From: Michael Harrison <mharrison@enviroassets.com>
Sent: Friday, June 23, 2017 3:15 PM
To: Nowell, Keith, Env. Health
Cc: Roe, Dilan, Env. Health; John R. Till Esq. (jtill@PaladinLaw.com); Peter Ton (pton@ww-envlaw.com); Jonathan W. Redding
Subject: Comments on LRM, Supplemental Remedial Investigation Workplan, June 19, 2017 (RED HANGER KLEANERS - T10000000416)
Attachments: EA22556-17 Comments LRM 2017.pdf

RE: LRM, *Supplemental Remedial Investigation Workplan*, June 19, 2017 (“Workplan”)

EnviroAssets has reviewed the LRM *Supplemental Remedial Investigation Workplan* (“Workplan”) for the former Red Hanger Kleaners at 6239 College Avenue in Oakland, California on behalf of our clients; Visilios D. Bouzos and Eleni V. Bouzos, individually and as trustee of the Bouzos Family Living Trust; and Dan Bouzos. The Workplan presents a variety of actions intended to address “correspondences dated April 18, 2017 and April 20, 2017” from the Alameda County Environmental Health. Please note that we were unable to locate these correspondence on GeoTracker and therefore have not reviewed them at the time of writing, and present our comments in the order that Workplan issues were identified, wi

Figure 2
 Site Plan Showing PCE Concentrations in Groundwater
 Red Hanger Cleaners
 6239 College Avenue
 Oakland, California

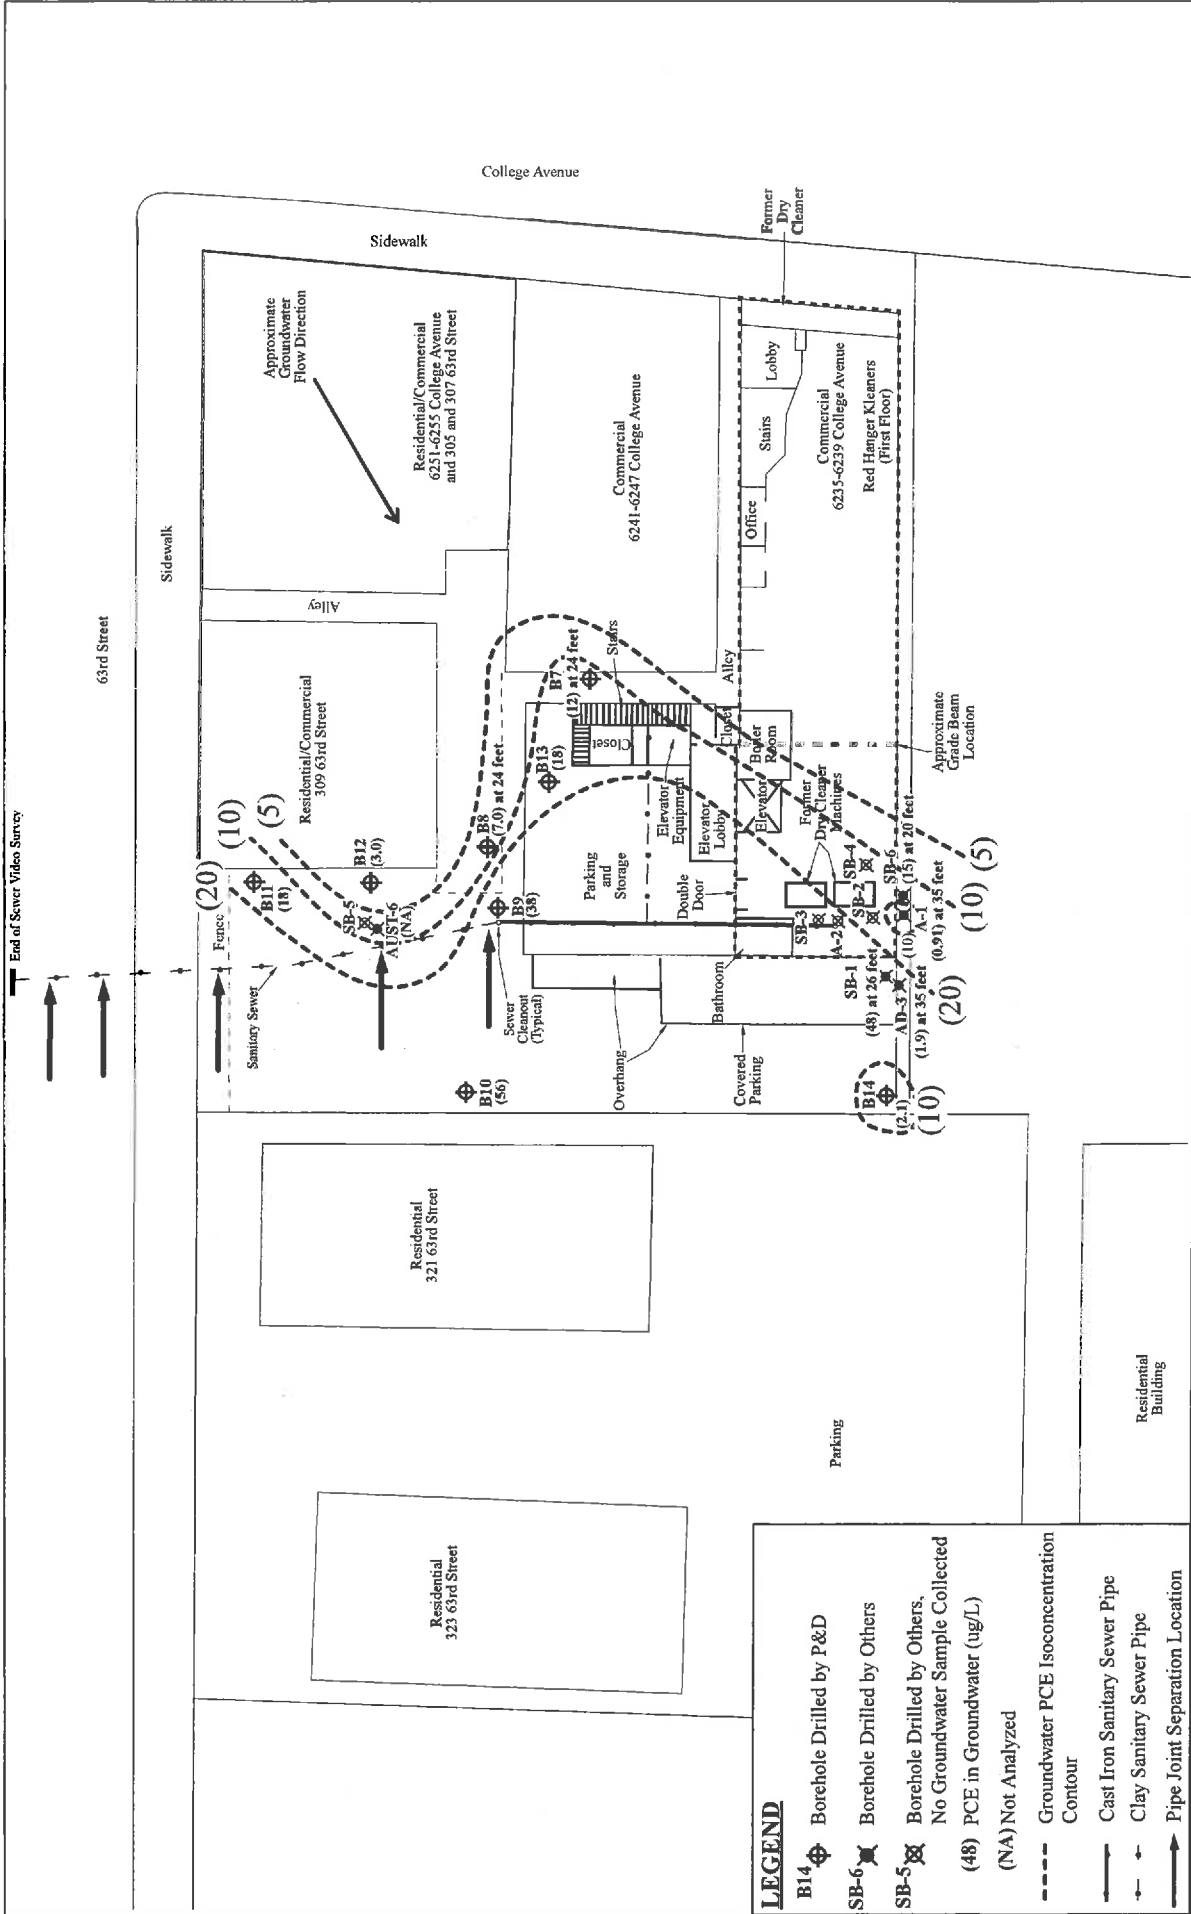
The Workplan states that “the data reported on to date does appear to suggest is that other sources/releases of dry cleaning chemicals have occurred beyond the limits of the 6235-6239 College Avenue property” but provides no discussion or rationale for this conclusion and attaches only the groundwater contour from P&D 2016. Contrary to this assertion, the groundwater and soil vapor data presented on figures 2, 7, and 8 of P&D 2016 (attached) point to the “parking and storage” area behind the former dry cleaning operations at 6235-6239 College Avenue and the damaged sewer lateral as the source of the contamination as the highest measured soil vapor concentrations are located in that area with decreasing concentrations observed in groundwater and soil vapor up-gradient of the source areas and the highest groundwater concentration observed downgradient of the source area at B10.
